ZONING BOARD OF APPEALS

TUESDAY, JULY 23, 2019 @ 12:00 PM

Consider a Request by Senergy Builders, LLC for a Variance to Reduce the Required First Floor Height from 15 feet to 12 feet 4 inches Located at 130 North 4th Street.

The Confluence

EXTERIOR ELEVATIONS

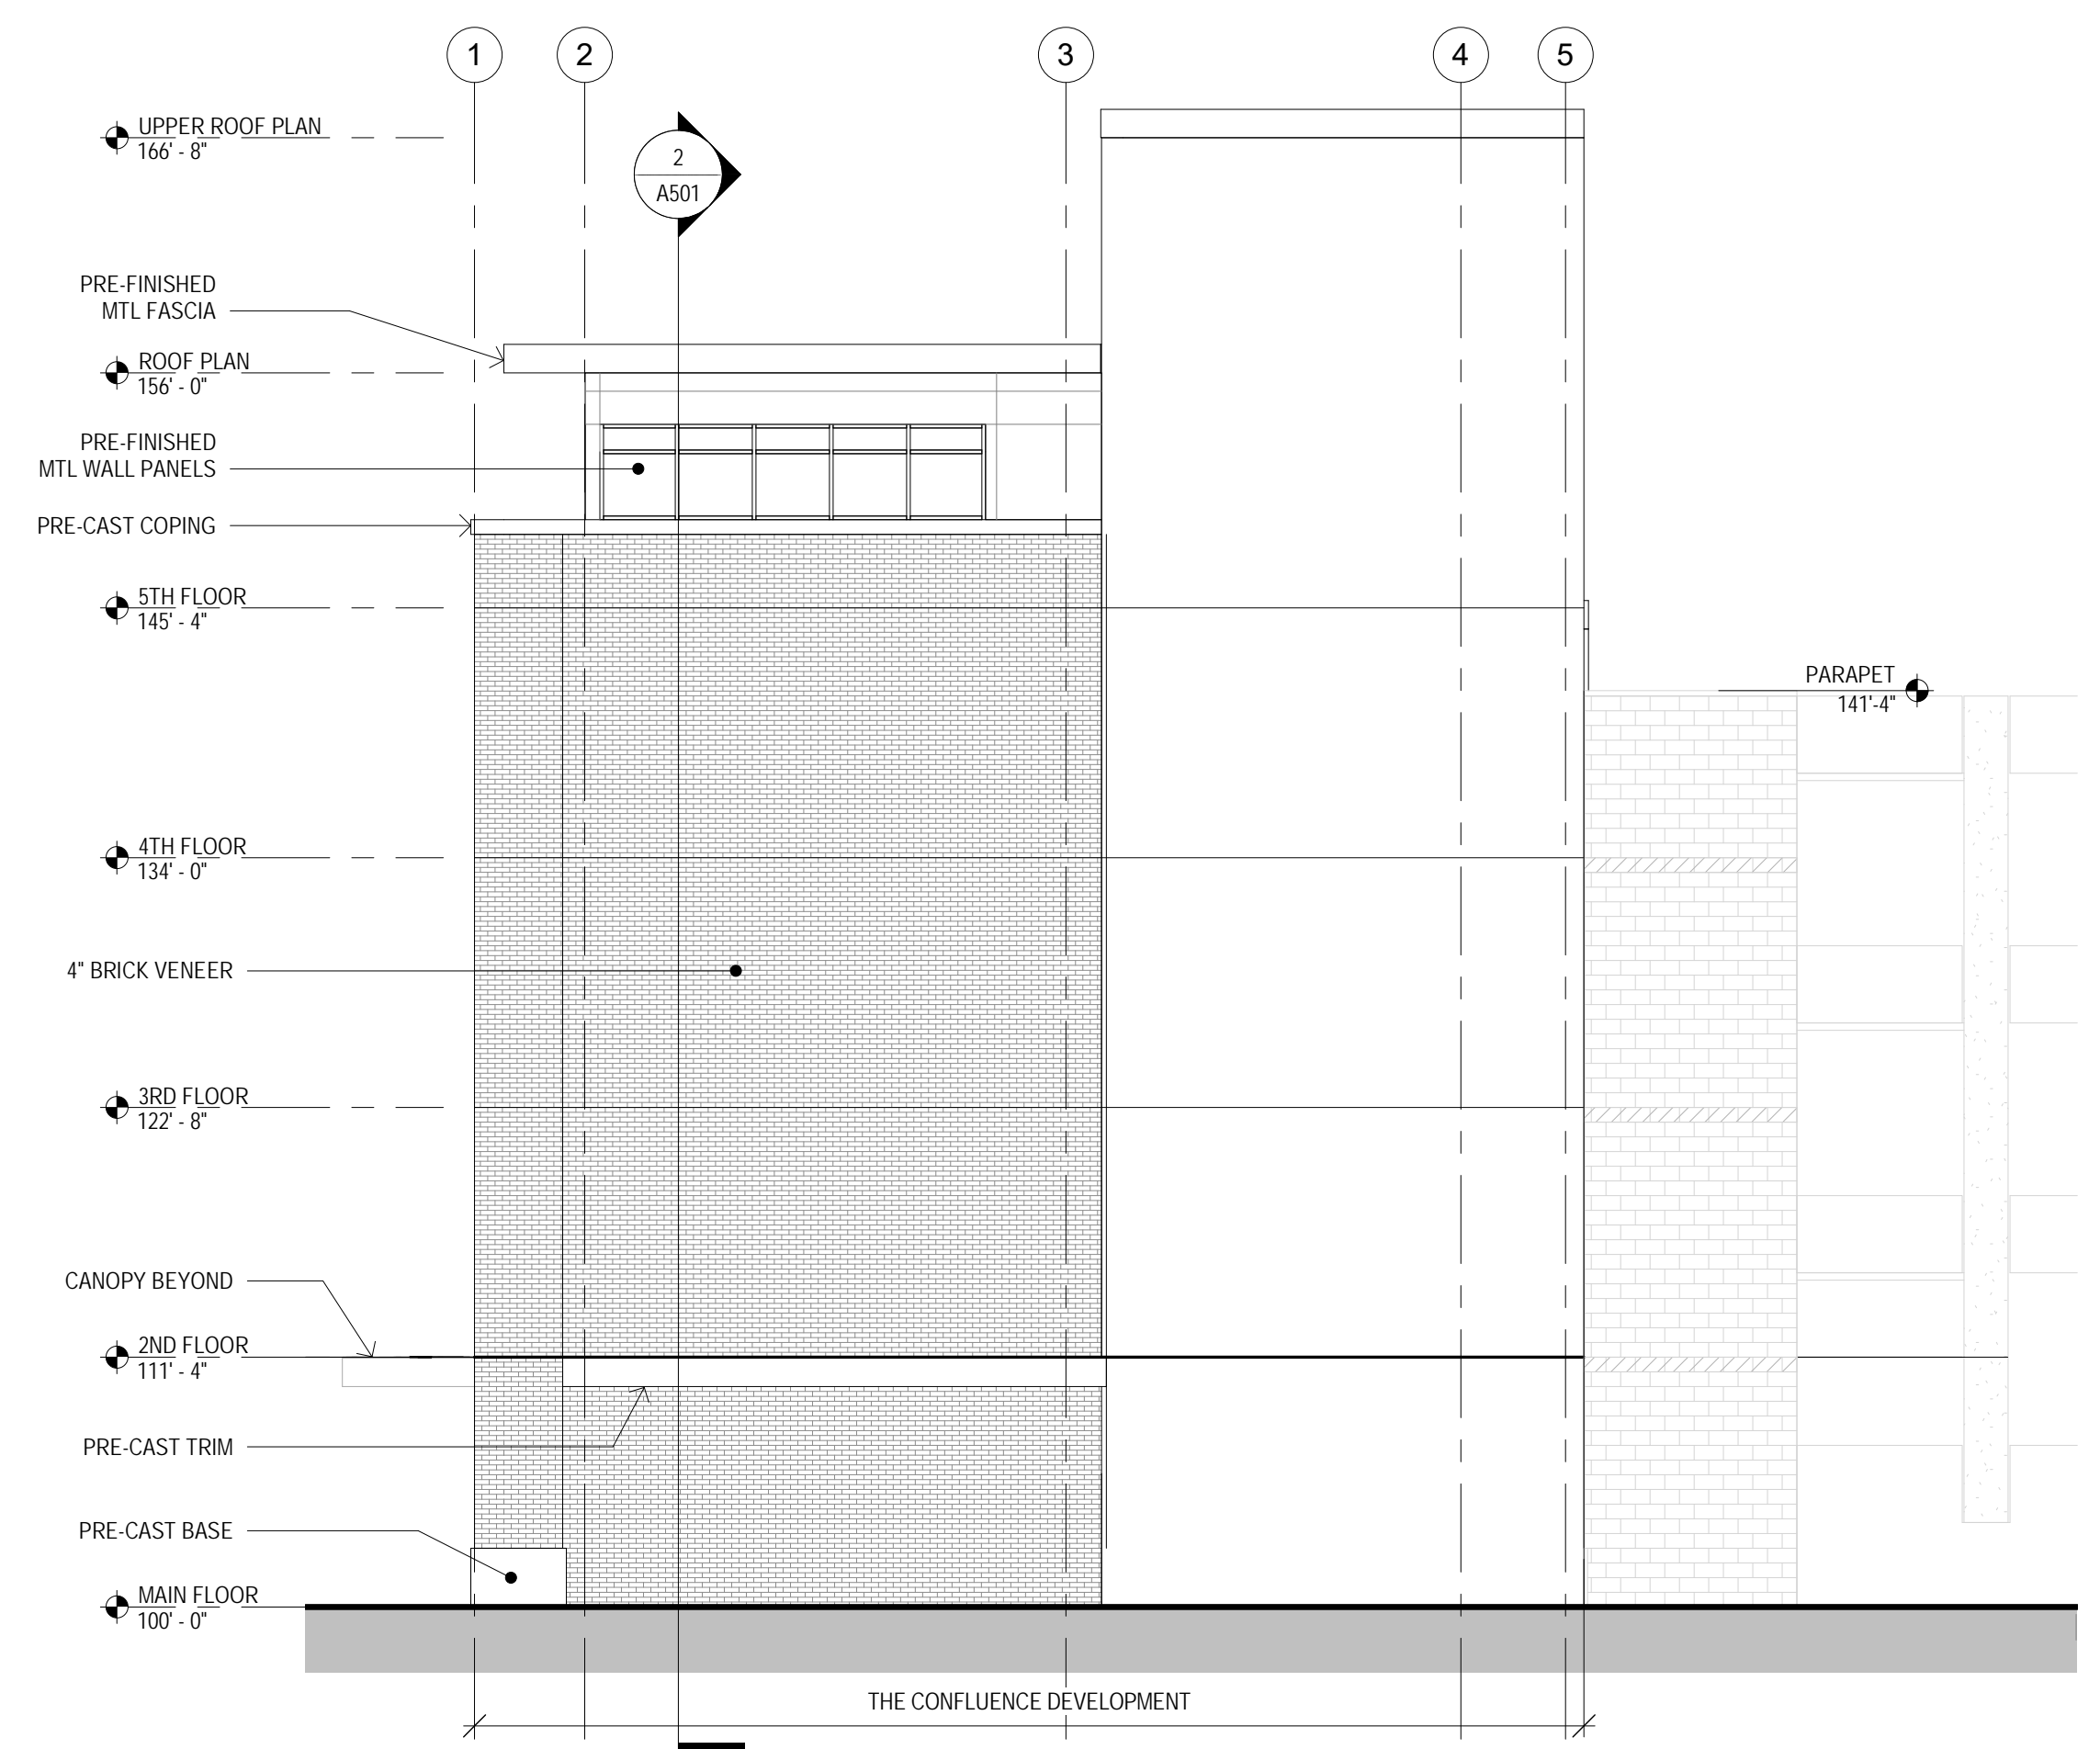
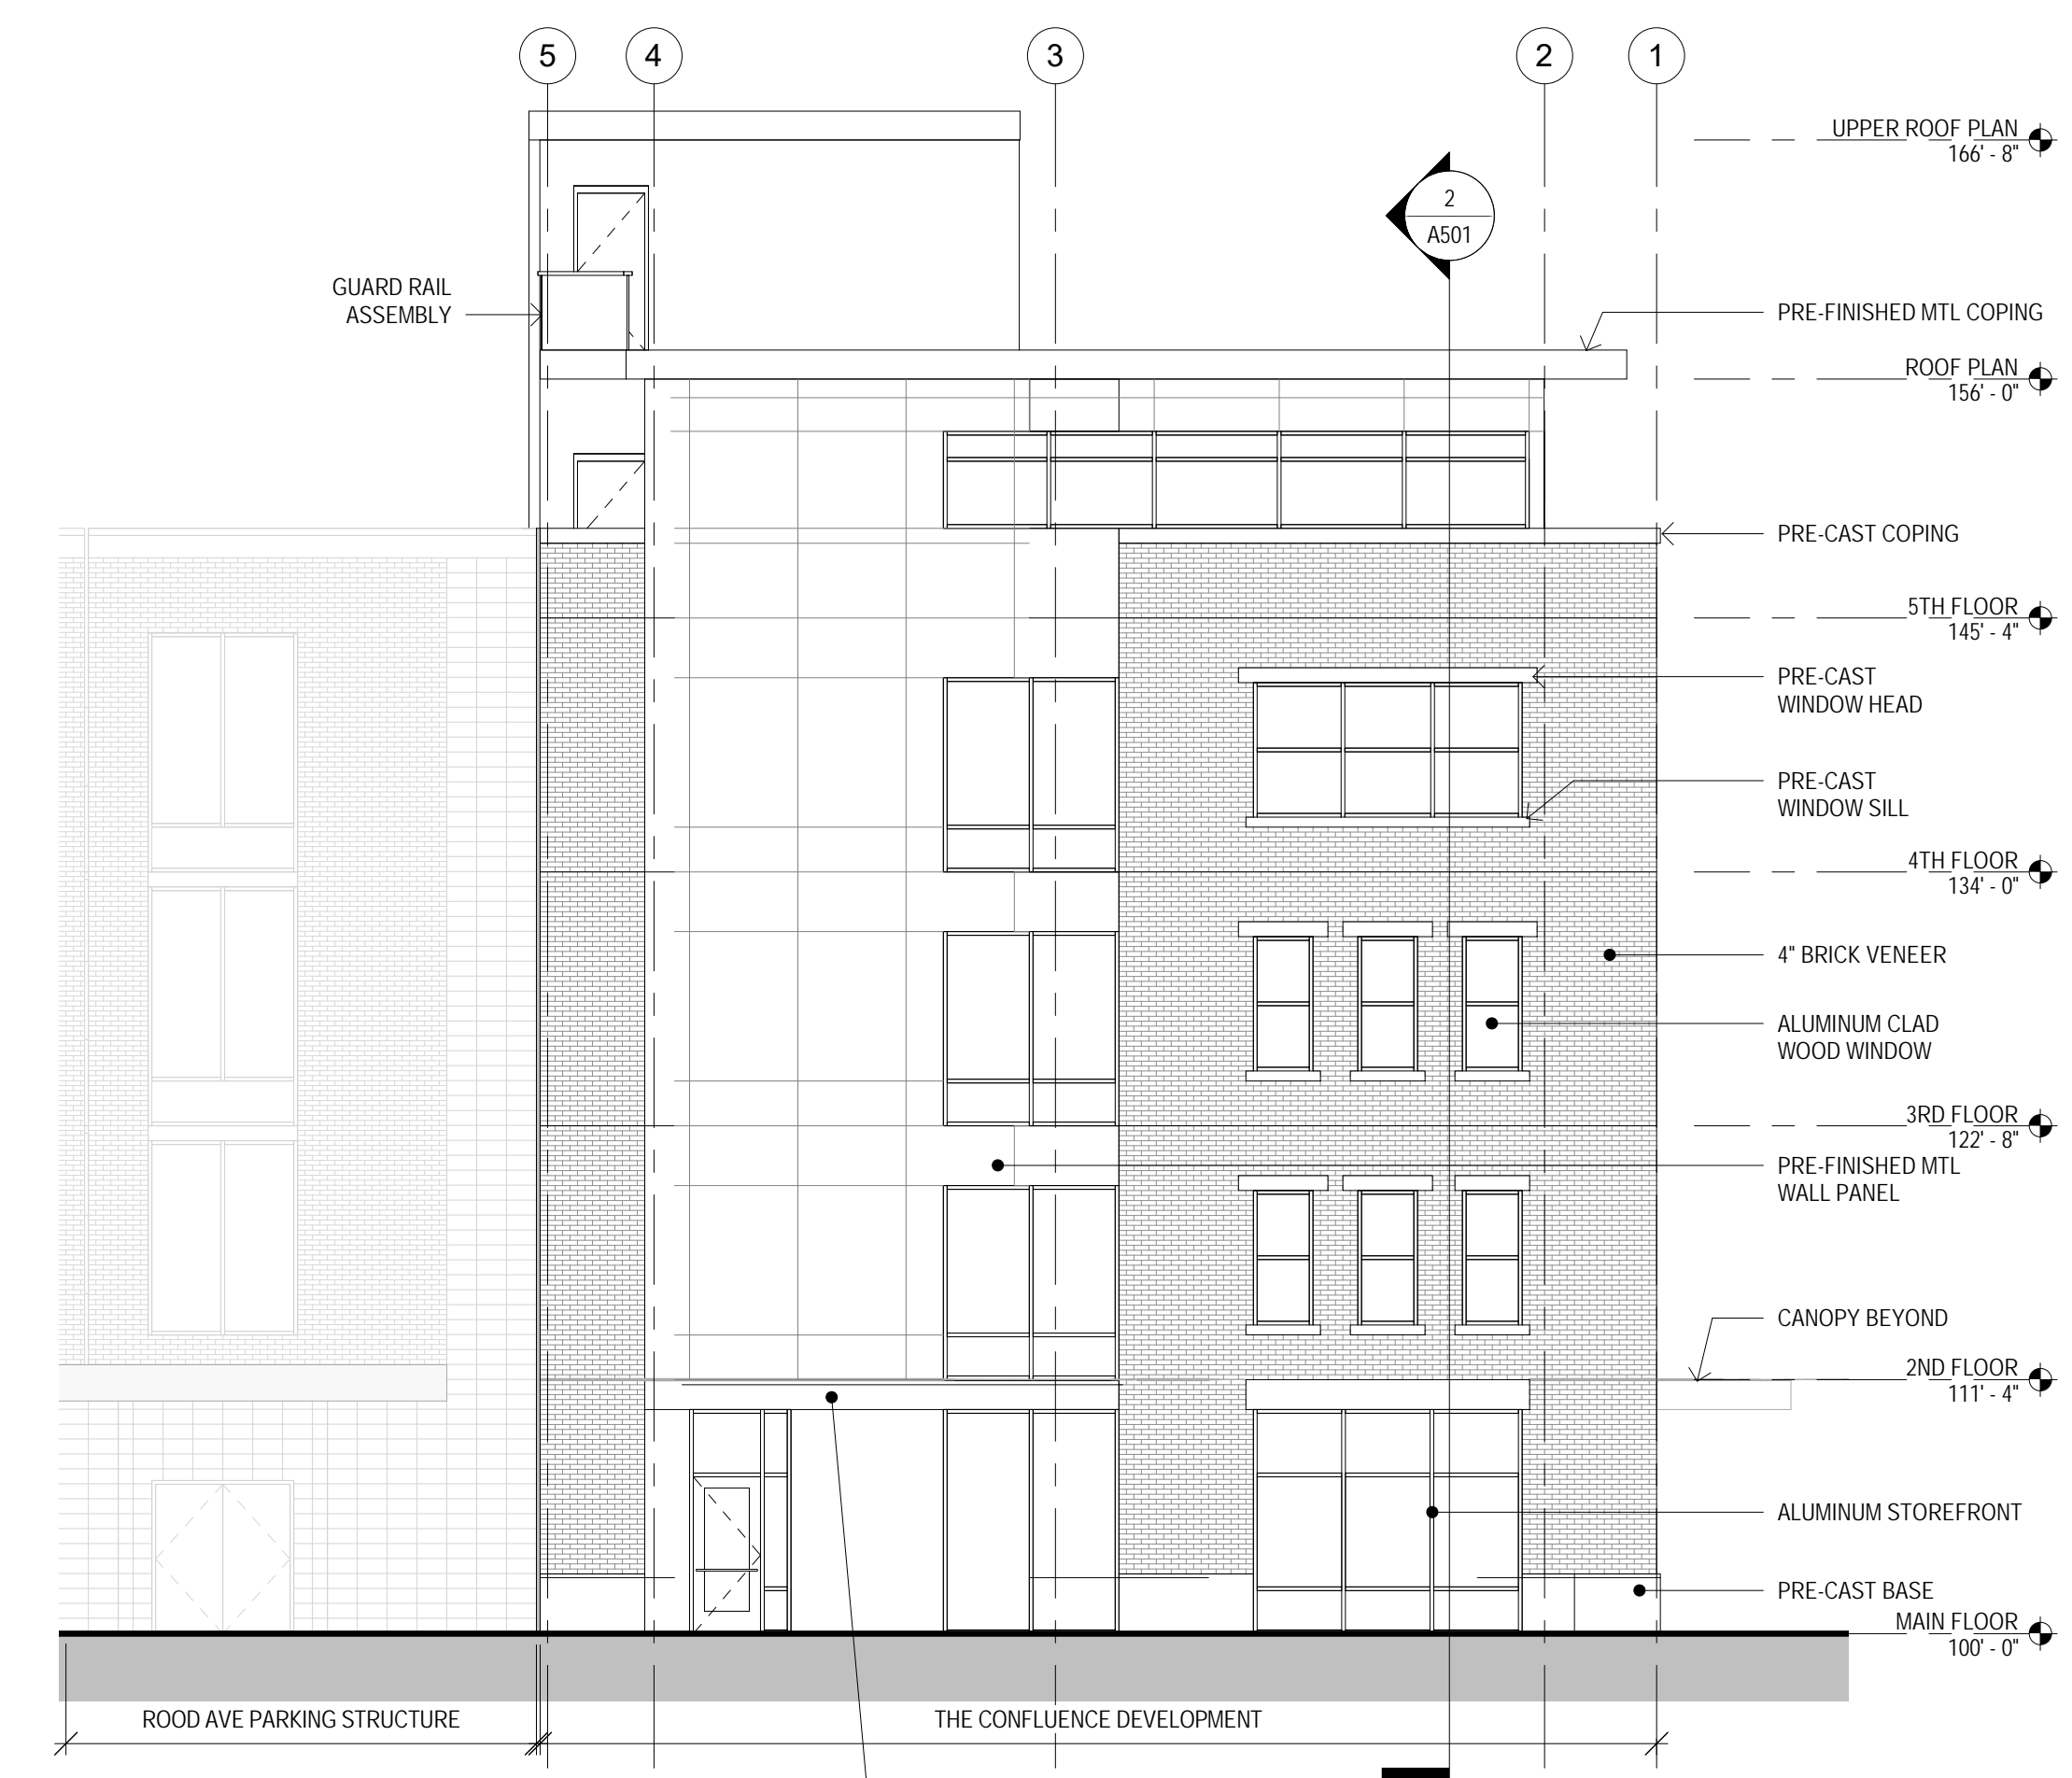
Based on the General Project Report, the Applicant has stated that the hardship is the construction of the parking garage under a different Zoning and Development Code and Building Code from that currently being used. In addition, the Applicant is proposing to match the floor levels of the adjacent parking garage and provide for direct access from the existing elevator in the garage from each of the floors in the proposed building. However, the building can certainly be constructed such that it meets the 15-foot first floor height requirement and utilize the parking garage, just not physically connect to the elevator on each floor. As such, there is no hardship and the

need for the variance is self-inflicted by the applicant's design that has been completed without regard to the Code standards.

The literal interpretation of the Code that includes the requirement of a 15-foot first floor height does not deprive the applicant of rights commonly enjoyed by other properties in the B-2 zone district. The subject property may still enjoy development rights for the scale and type of project proposed without the variance. Staff concludes that this criterion has not been met.

The request is to vary the first floor to a buildable height of 12 feet 4 inches in order to match the access points on the parking garage on each level is a variance of 2 feet 8 inches. This is difference needed to align the first floor height with the parking garage elevator openings and thus is the minimum necessary to make possible the use of this proposed structure. Staff therefore, finds this criterion has been met.

The literal interpretation is that the first floor be 15 feet in height. This is likely due to the desired appearance of having an architectural form that follows the perceived function of downtown in providing spaces to commercial businesses. While this is agreeably so desirable, many of the existing downtown buildings do not meet this criteria. The applicant is seeking to match the RAPP first floor height of 12 feet 4 inches as was intended in the design of RAPP.

The architect has brought the glass line up to the ceiling height and then pushed up each of the steel canopy's an additional 2 feet in order to give the appearance of compliance while achieving the desired architectural standard. See architectural drawing sheet A201. It was the intent of the City and the DDA to build building on each of the RAPP Endcaps and connect the two structures to the parking garage and; to share the use of the two elevators. A 15 foot first floor height makes this unworkable.
